Road Safety Audit
Stage 1
for
PROPOSED HOUSING DEVELOPMENT
AT
RATHMULLAN, CO MEATH

Reference: RSM/MOB/121118/RATHMULLAN RSA1

Client	Waterman Moylan Consulting Engineers
Project Title	Proposed Housing Development, Rathmullan, Co Meath
Document Title	Stage 1 Road Safety Audit
Document Ref.	RSM/MOB/121118/RATHMULLAN RSA1
Status	FINAL

Figure 3

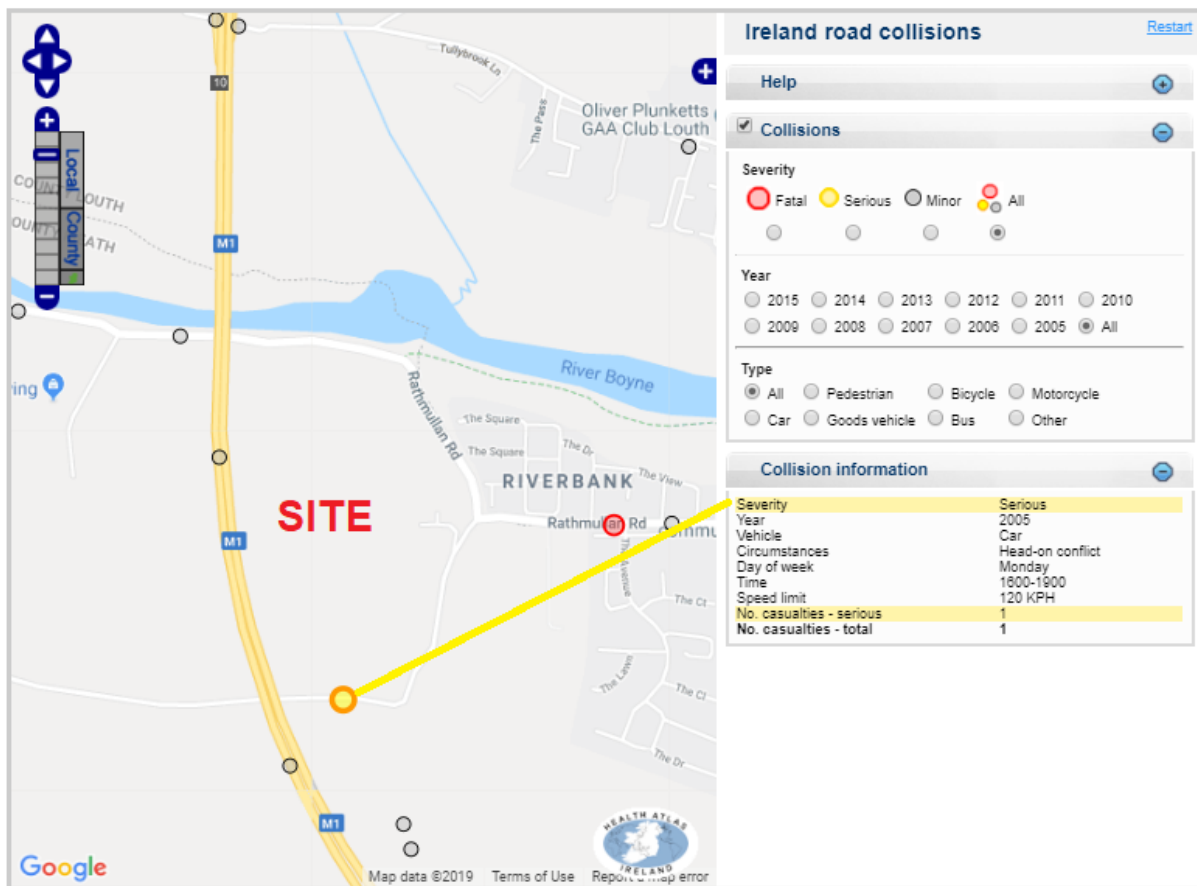
2.1.3 No information was provided on any existing collision statistics in the vicinity of the site. A review of the Road Safety Authority (RSA) online collision database indicates that there was one serious collision recorded on the existing road network immediately adjacent to the proposed development site between 2005 and 2015 inclusive, at the location shown in figure 3. The collision involved a head on conflict, and it was noted on site that the carriageway cross section is relatively narrow at this location, which is likely to preclude safe two way movement at all times, and which should be considered in improvement of the road network surrounding the site.

Figure 25

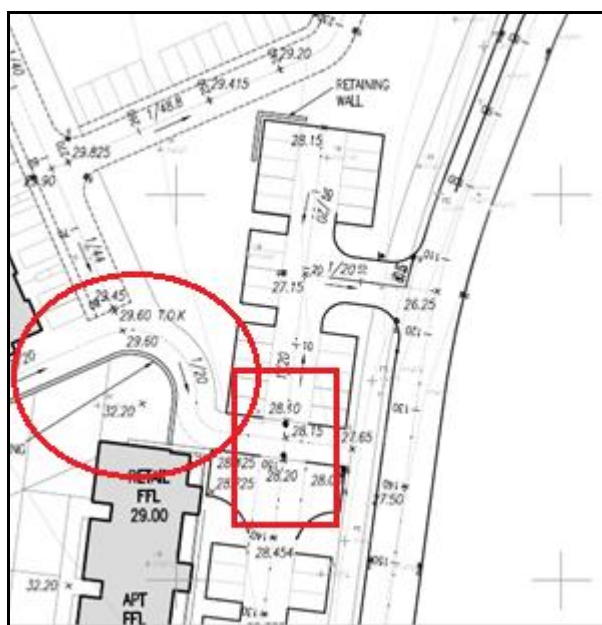
There are significant level differences within the site, leading to gradients of 5-8% at some locations, including a 5% gradient on the eastbound approach to the stoplines at the signalised crossroads, which will present difficulties for some road users. Figure 25 shows a location where there is a 1/20 gradient in 3 directions with no level dwell area at the access point/intersection with Rathmullan Road. The general details in this area are unclear in respect of permissible movements, accessibility, alignment to the south and clearance to the proposed retaining wall. Inappropriate levels and relatively steep gradients on links within the site are likely to present difficulties for wheelchair access or for access for those with buggies or for elderly pedestrians. There were no cross sections provided for links throughout the site to determine any potential issues in terms of trip hazards or kerb heights, which may also present difficulties for mobility and visually impaired pedestrians.

The gradients and vertical design should be reviewed throughout the site, and a longitudinal profile produced at detailed design stage to demonstrate that all gradients throughout the site will be safe for use by all road users, and to minimise the risk of larger vehicles overturning on bends or encroaching into the path of oncoming vehicles, creating a head on collision risk. The proposals for access and clearance adjacent to the retaining wall shown in figure 25

should also be clarified. A recommended 600mm clearance should be provided to all solid boundaries within the site from the edge of carriageway, with a minimum 450mm clearance to be provided to all other boundaries, street furniture and signage.

2.2.4 Problem - Vertical Alignment	Yes	Longitudinal profile of roads to be produced at detailed design stage. In relation to Figure 25, levels have been reviewed and a dwell area can be provided at the access point / intersection with Rathmullan Road. Access proposals at this location are shown on drawing No. 18-014-P006 with additional information provided on the landscaping site masterplan.

Figure 27

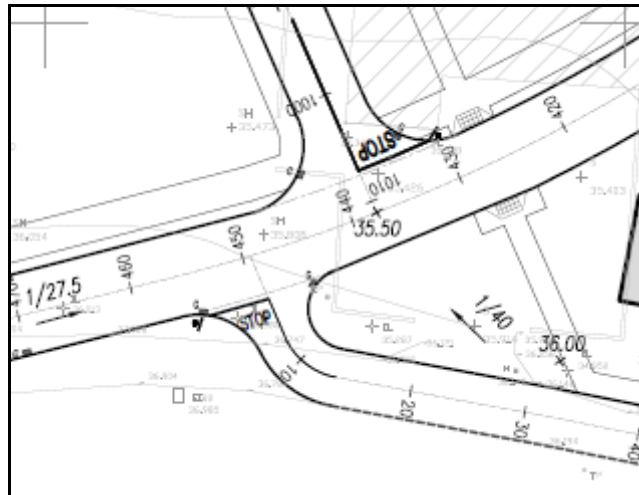
A number of existing access points may be effected by the proposed works, which have not been shown on the preliminary design layout, with an example shown in figure 26. Figure 27 shows two proposed access junctions to the north and south of Rathmullan Road where there is minimal stagger offset between the junctions, which increases risks to vehicles turning to and from these locations. There is no stagger offset provided at a number of internal junctions within the site, which have been configured as crossroads junctions. Crossroads junctions typically have higher collision rates than suitably staggered junctions due to the higher risk of crossover and right angled collisions, particularly where there may be obstructions in visibility splays to the left or right.

2.2.5 Observation - Proximity of Adjacent Access Points	Partially	Yes - All existing access points along Rathmullan Road will be retained as required.	We do not agree that internal junctions require additional staggering given these are within a low speed environment with suitable signage and traffic calming measures provided. Figure 27 - There are not expected to be any traffic movements across the main road at this location given that the southern arm only serves an apartment block and 2 No. existing dwellings. It is highly unlikely cars will access this road from the estate road to the north.	Yes

Figure 28

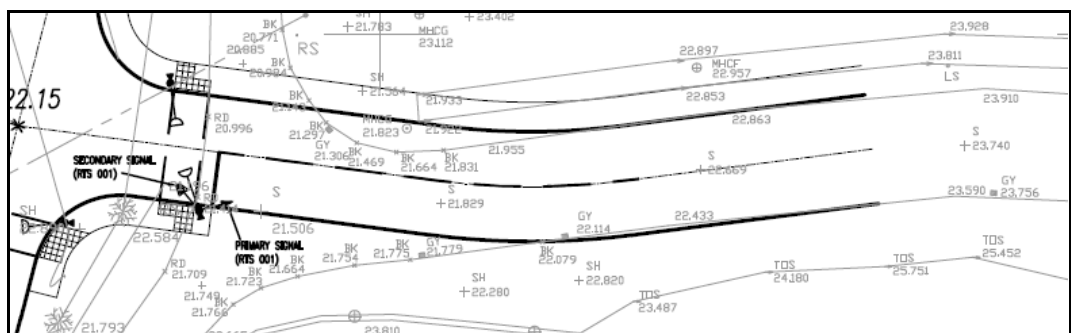
- There were a number of pedestrians observed walking within the carriageway of Rathmullan Road at the time of the site visit, where there is no current provision for and footways. The preliminary design layout shows a disconnected and discontinuous footway network along Rathmullan Road which is unlikely to fully cater for all existing and future demands.
- There is no footway continuity at the following locations:
 - on the southern side of the carriageway on the eastern arm of the signalised crossroads
 - on the eastern side of the southern arm of the signalised crossroads
 - On the western side of the northern arm of the crossroads
 - Figure 28 shows proposals for a footway on the northern side of the eastern arm of the crossroads, which appears to be tying into the existing verge, with a row of trees at this location, as shown in figures 29 and 30.

stage. Details of all kerbs to be provided as part of the detailed design. Footpaths within the site are a minimum of 2m and are in compliance with DMURS. The 1.2m pedestrian strips are proposed locally within home zone / shared surface areas which is also permitted under DMURS. Crossing points are identified on the updated layout drawings, please refer to drg No's 18-014-P003, P004, P005 and P006. These drawings also include for the provision of tactile pavement as necessary.

Figure 31

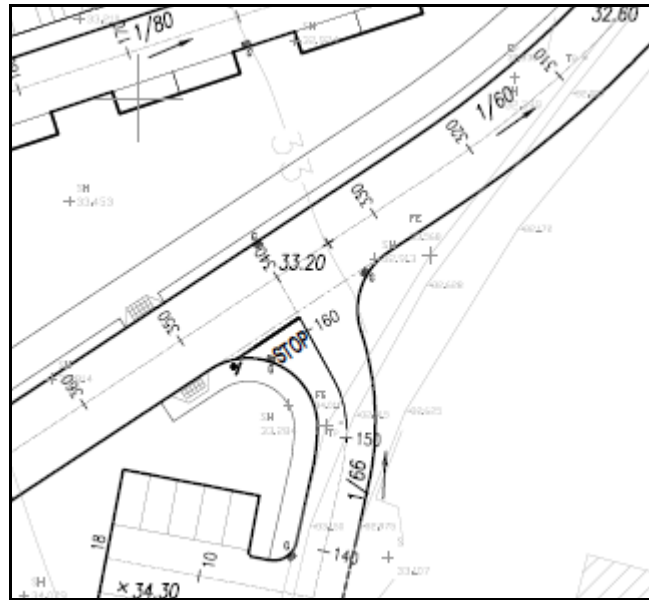
- The footpath also terminates abruptly adjacent to the southern section of the site, however provision has been made for an informal pedestrian crossing point at this location. Clear forward visibility to and from both sides of the crossing from a point 2m back from the kerbline will be required at this location. It was noted that the sign provided at the stop controlled junction at this location is likely to obstruct the footway, and should be moved to

the back of footway and installed on a cranked pole, or the footway width increased, with a minimum 450mm clearance to be provided from the edge of signface to the kerb edge.

Figure 32

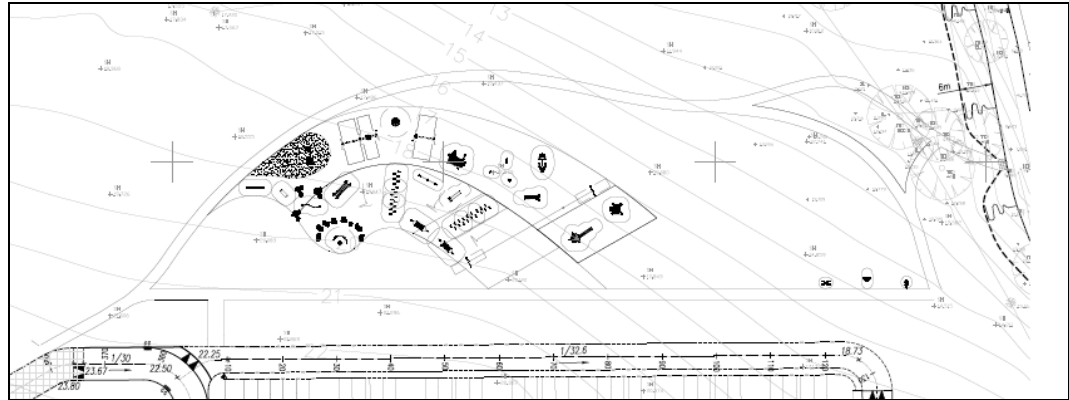
- The continuity of the footway shown in figures 32 and 33 is unclear from the plans supplied, and there appears to be provision for pedestrians to cross the carriageway to access the river walkway, which is shown in figures 34-36. Visibility to and from pedestrians waiting to cross at the potential crossing point shown in figure 33 is likely to be compromised by horizontal curvature, embankments and dense vegetation. Visibility to and from all formal and informal crossing points throughout the scheme should be clear and unobstructed in accordance with traffic speeds, with pedestrians to be visible from a point 2m back from the road edge. Safe connectivity to the river walkway should be provided on both side of the carriageway.

Figure 39

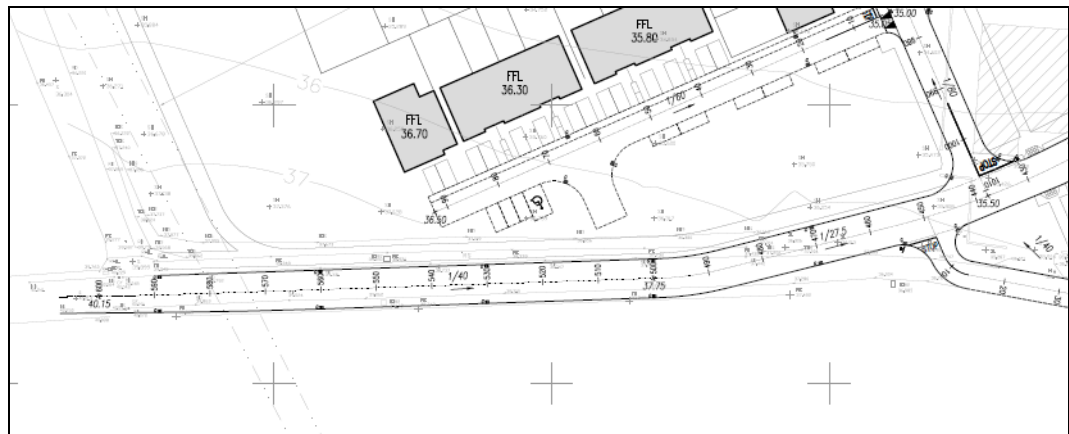
- It was noted that there is a significant level difference at present along the southern boundary of the site, on the approach to the M1 overbridge, as shown in figure 38. The site proposals indicate provision for a footway along this boundary, which is shown in

figure 39, however the design plans do not show details for earthworks or fencing at this location to address the level difference.

Figure 40

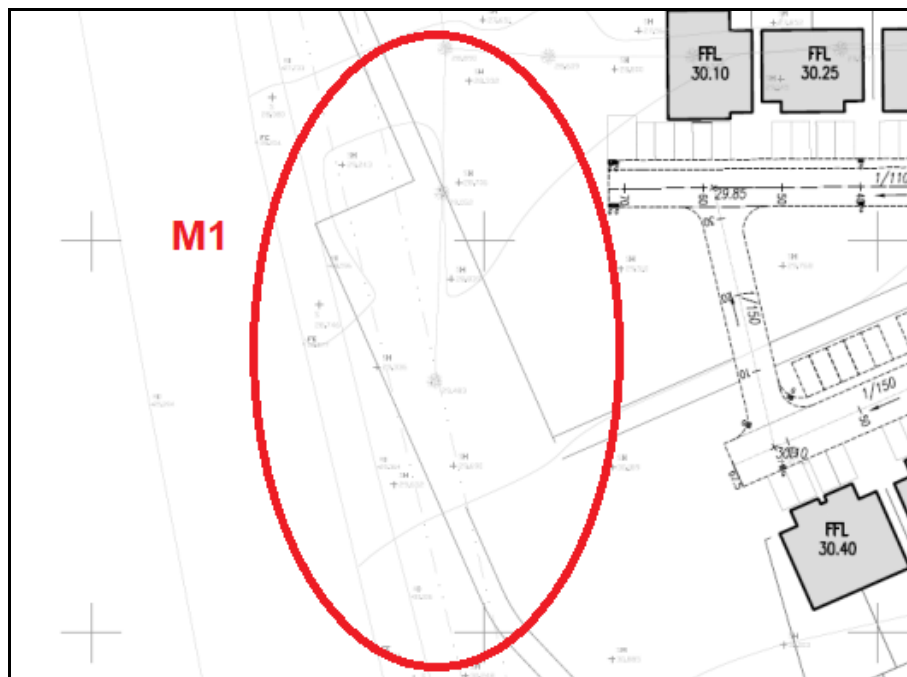
- The proposals for the area to the west of the site, shown in figure 40, are unclear from the plans supplied. This area is located immediately adjacent to the M1 motorway, where there are significant embankments, level differences and dense vegetation, as shown in figures 41 and 42. The proposals for this area should be clarified at detailed design stage to ensure there is no impact on the motorway operation, including the potential for lighting interference, with safe secure fencing to be provided to prevent child access onto the motorway.

Figure 43

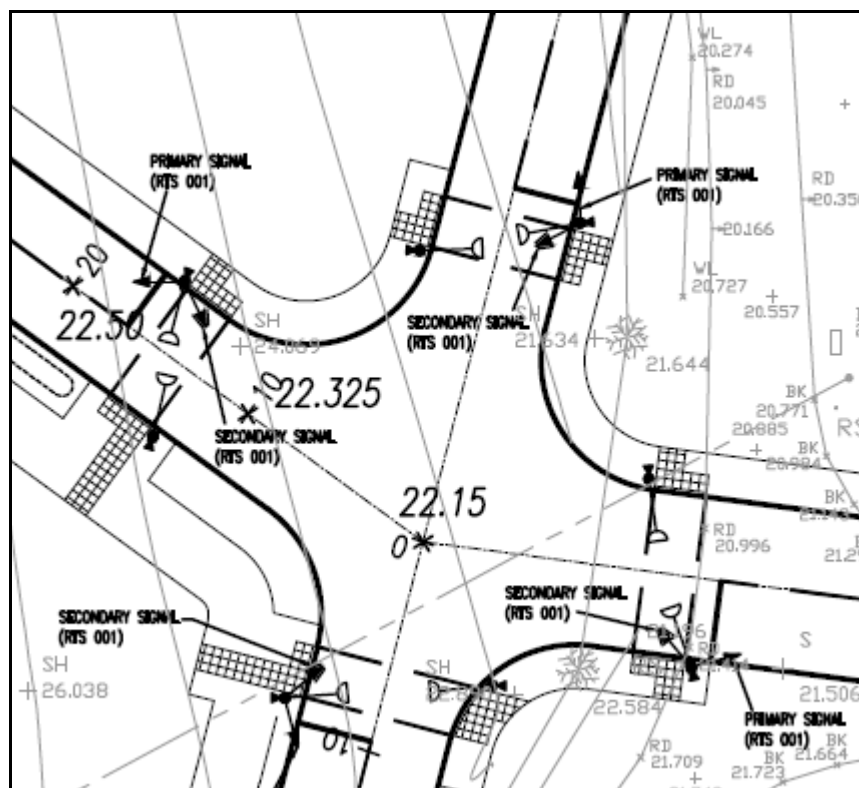
- Stoplines appear to be located too close to crossings at the signalised crossroads, as shown in figure 43, presenting an increased risk of vehicular over-run and potential for vehicular/pedestrian conflict.

2.4.2 Problem - Signing and Lining	Yes	Signage and lining to the appropriate standard will be provided throughout the development.
